## Powertech comment C58 on the Cumulative Effects Analysis document.

Figure 25. Projected Construction, Operation and Decommissioning Schedule at the Dewey-Burdock Project Site

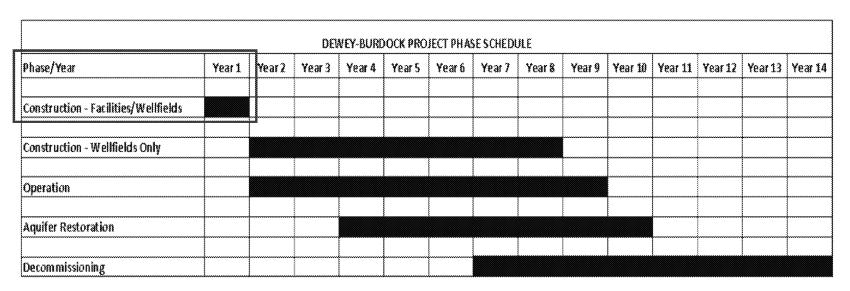
I thought I would clarify what I was trying to say in that confusing sentence highlighted in yellow.

My Questions: In Table 30, is the 542 metric tons of CO2 emissions from electrical power consumption during the construction phase all attributable to facilities construction? Is all facility construction accounted for in year 1?

I was confused because NRC's SEIS Table 2.1-6 (next slide) identified the 542 metric tons as an annual amount for construction phase. I guess that is true, but annual only for the first year? If 542 metric tons is from only facilities construction and during the first year, I will update this table in the CEA to reflect that info (not multiply 542 by 9) and include that info the response to comment C58. How about decommissioning? Is the 542 metric tons an annual amount for 8 years of decommissioning activity? Or is all disassembling of facility structures accounted for in one year & I shouldn't multiply 542 by 8?
